# HISTORIC AND DESIGN REVIEW COMMISSION

**HDRC CASE NO:** 2020-284  
**ADDRESS:** 724 N PINE ST  
**LEGAL DESCRIPTION:** NCB 1659 BLK G LOT 3  
**ZONING:** R-6, H  
**CITY COUNCIL DIST.:** 2  
**DISTRICT:** Dignowity Hill Historic District  
**APPLICANT:** Sunnie Diaz/SOFLIN DAVID & DIAZ SUNNIE R  
**OWNER:** Sunnie Diaz/SOFLIN DAVID & DIAZ SUNNIE R  
**TYPE OF WORK:** Demolition of a rear accessory structure new construction of rear accessory structure  
**APPLICATION RECEIVED:** May 21, 2020  
**60-DAY REVIEW:** Not applicable due to City Council Emergency Orders  
**CASE MANAGER:** Edward Hall  
**REQUEST:**

The applicant is requesting a Certificate of Appropriateness for approval to demolish the rear accessory structure at 724 N Pine.

The applicant is requesting conceptual approval to construct a rear accessory structure to replace the existing accessory structure that is proposed to be demolished.

## Exterior Materials at Garage

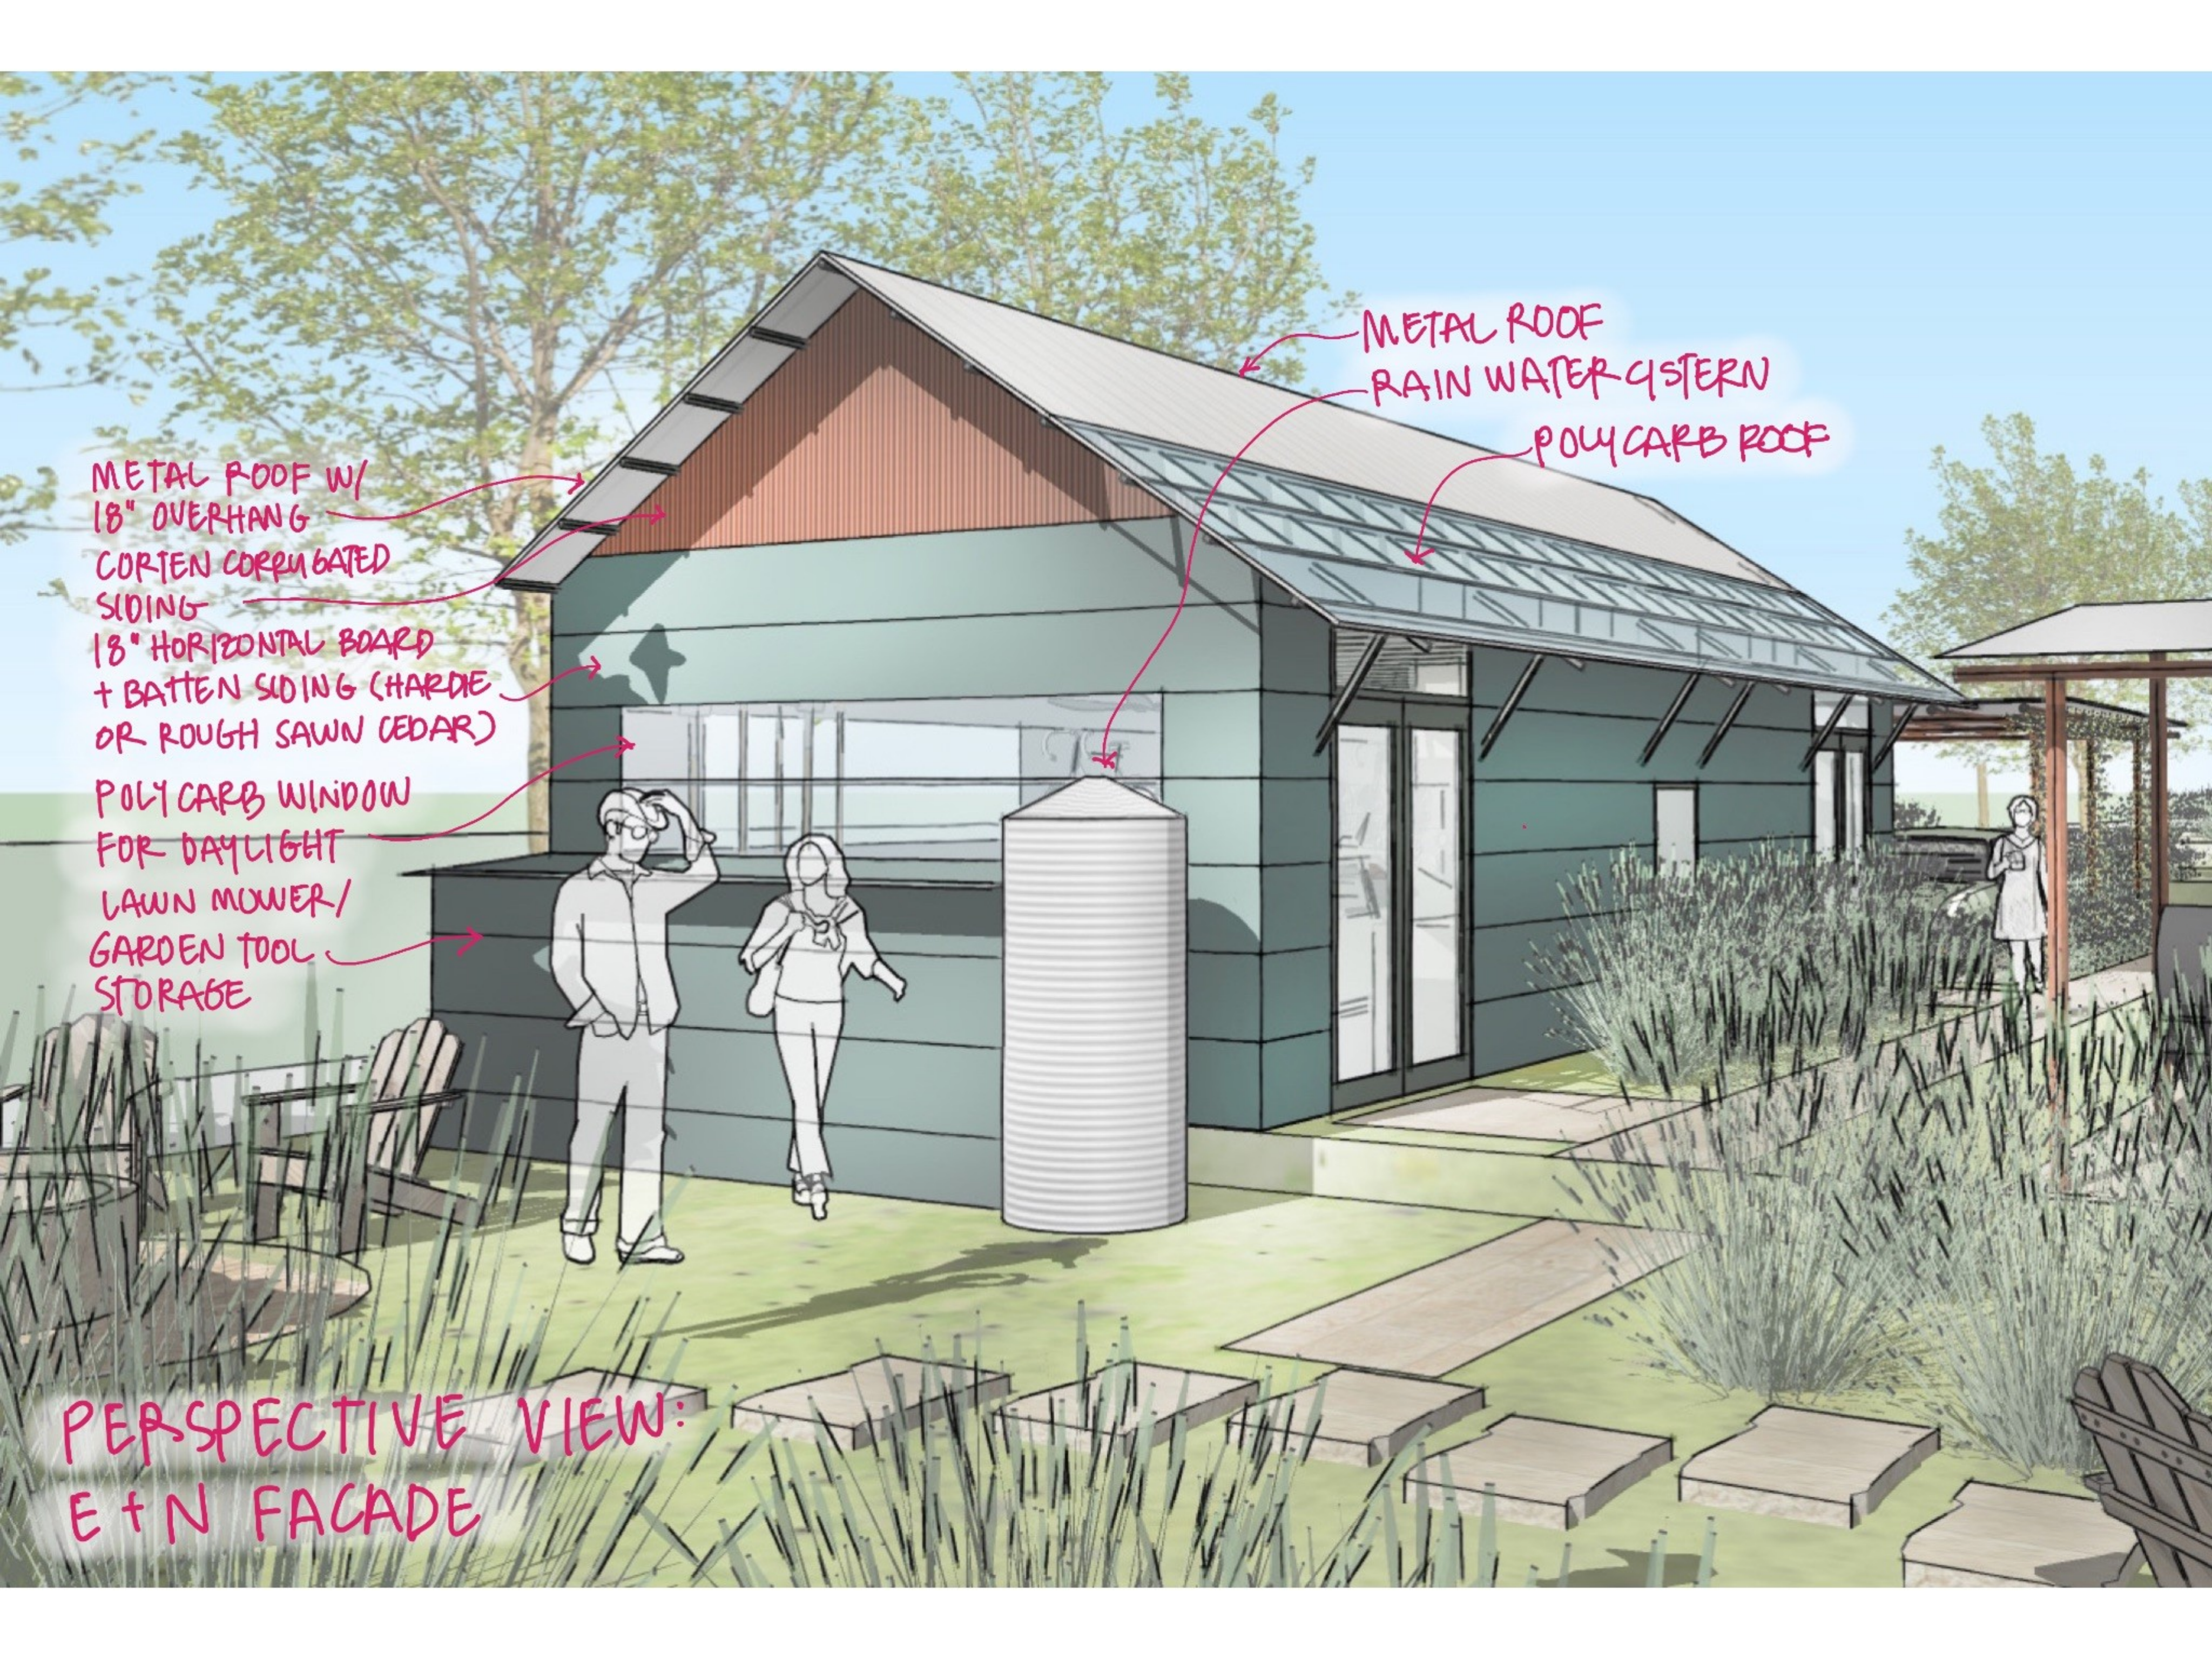
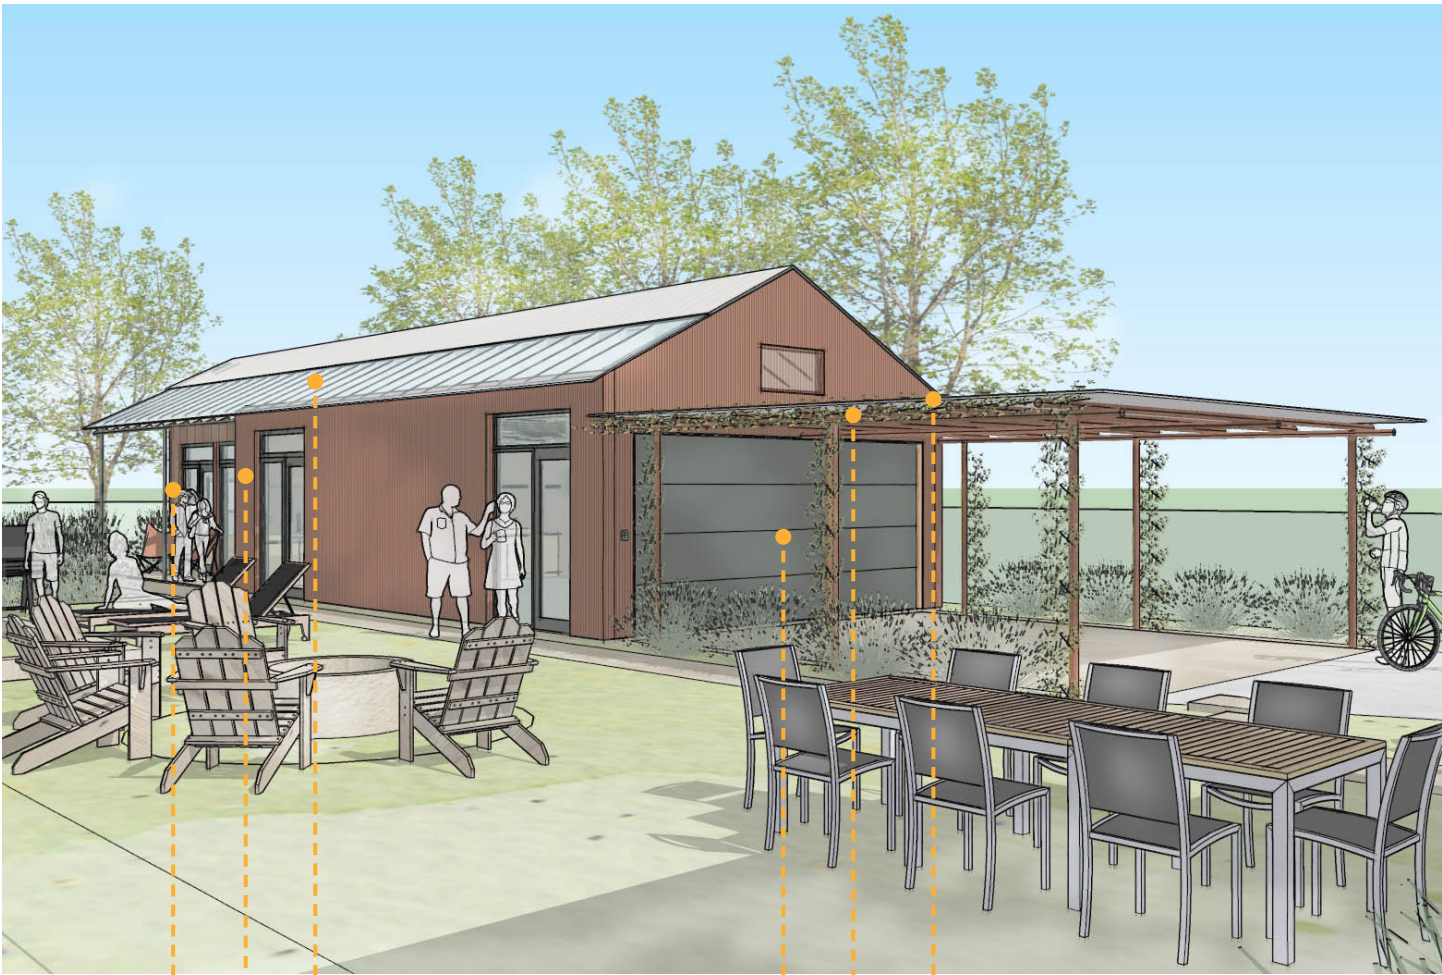
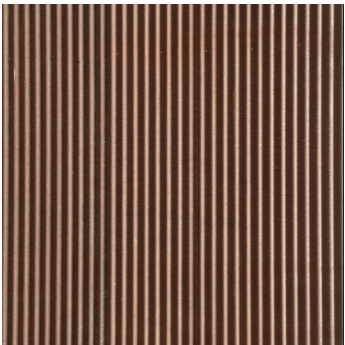
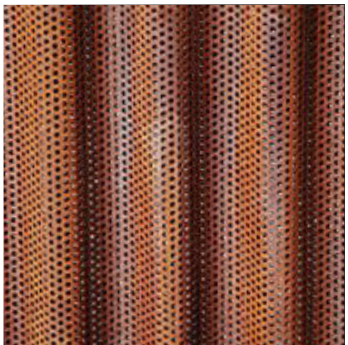
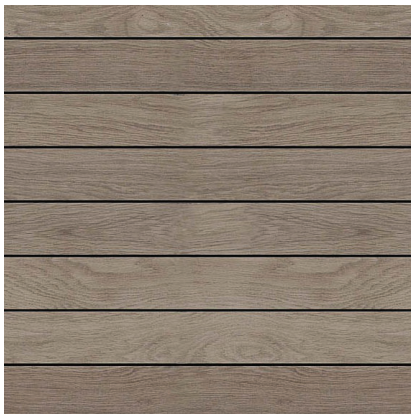
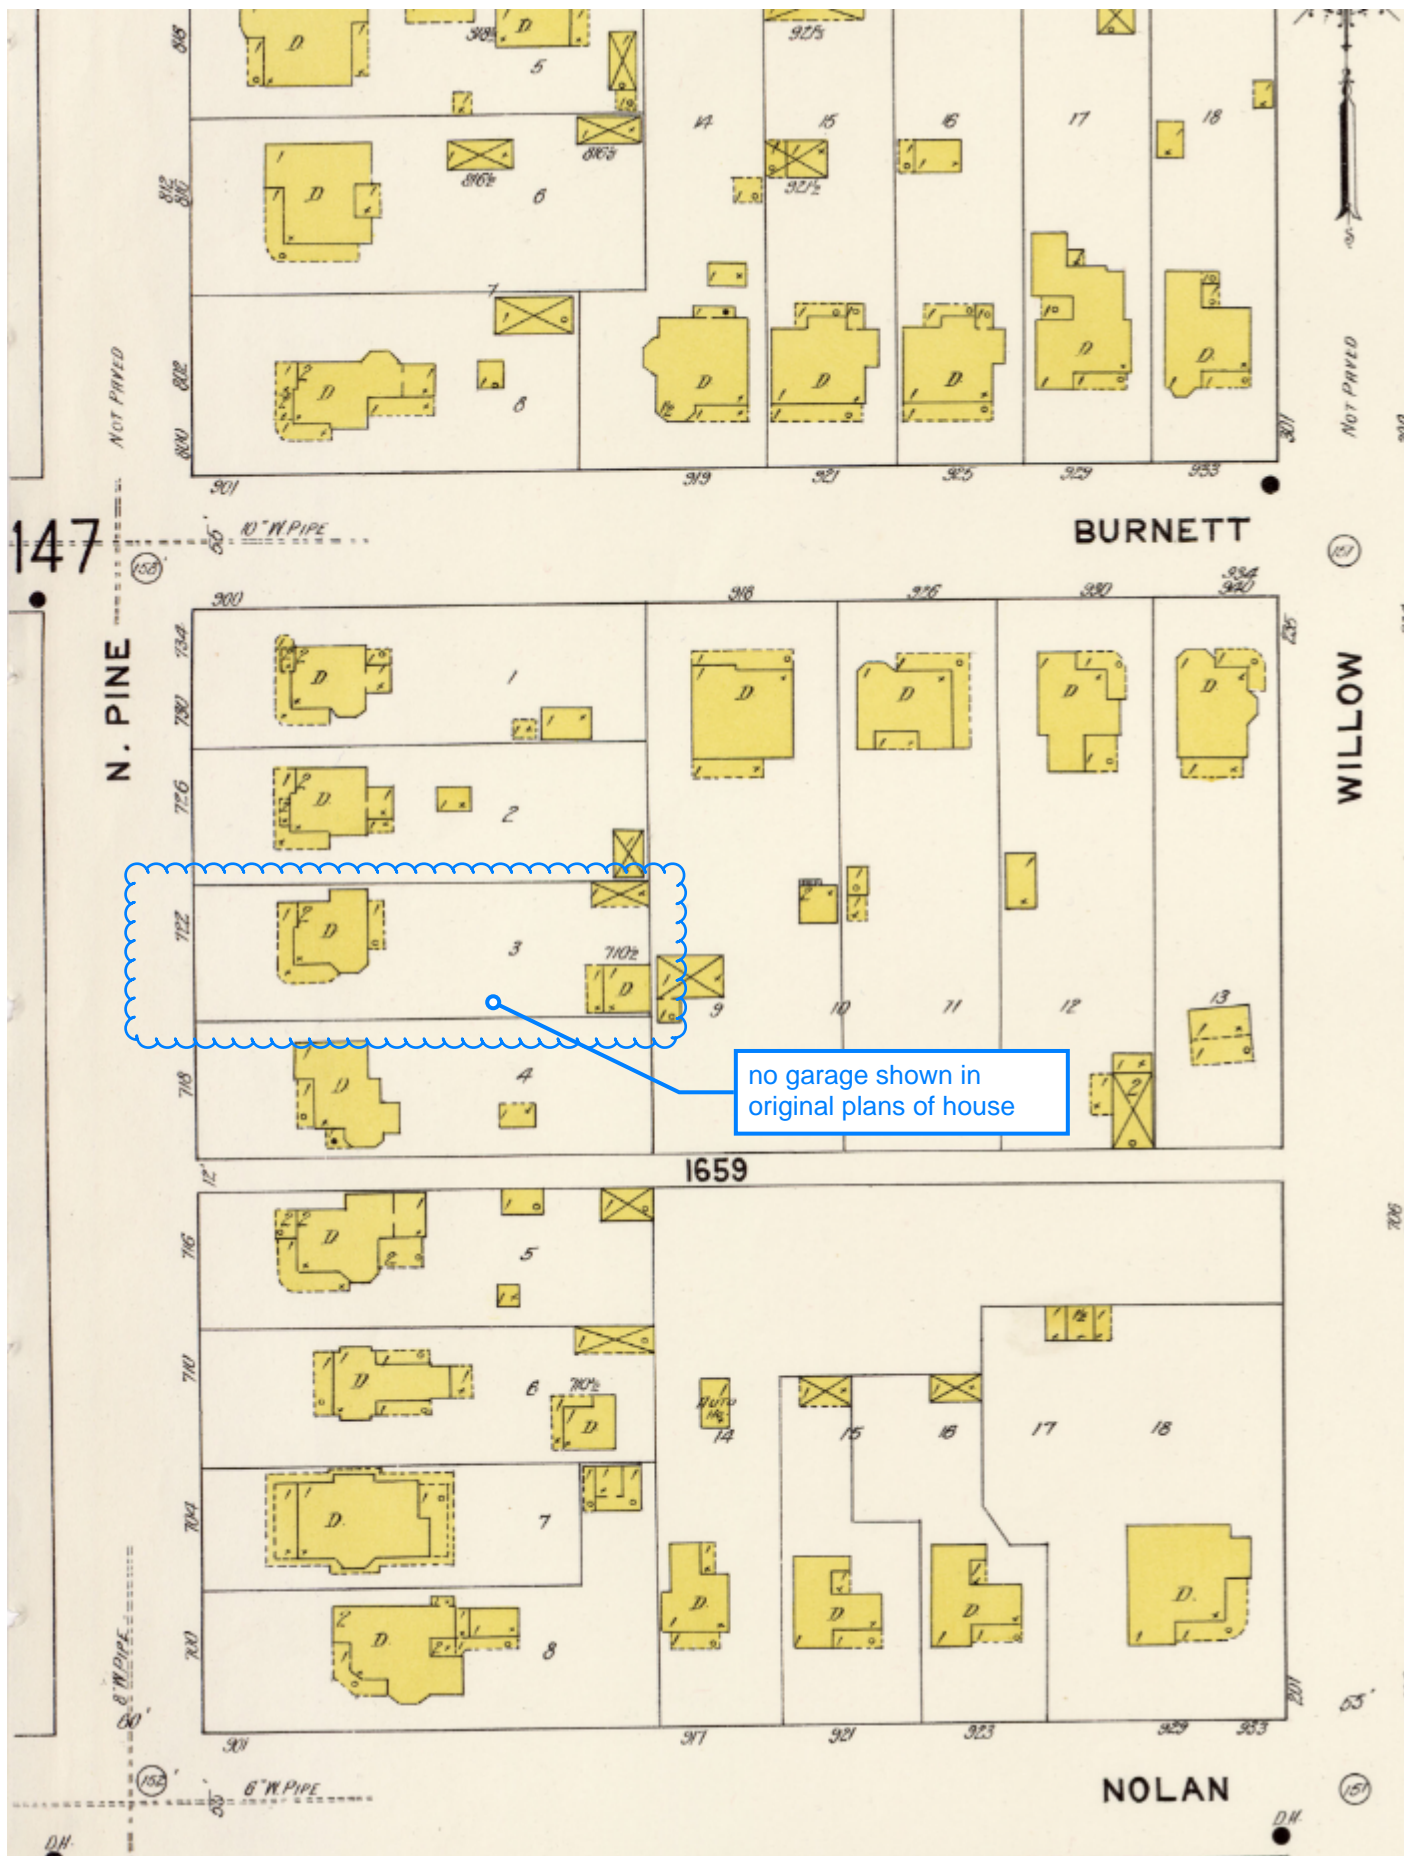
- k. **CHARACTER** – The Guidelines for New Construction 5.A. notes that new accessory structures should relate to the primary historic structure in regards to their materials and window and door openings. The applicant has proposed materials that include poly carbonate roofing materials, corrugated corten siding, perforated metal, wood siding, a corrugated metal roof and a standing seam metal roof. Per the Guidelines, materials that are found historically within the district should be used in new construction. Corten metal, poly carbonate roofing and corrugated metal roofing are not found historically within the district. Staff finds that materials that are found historically within the district should be used in the new construction.

Staff recommends conceptual approval of the proposed massing and footprint of the proposed accessory structure based on findings f through k. Staff recommends that the applicant utilize building materials found historically within the district in the development of the proposed new construction, and that materials that are not deteriorated beyond use be salvaged from the existing structure and incorporated into the proposed new construction.
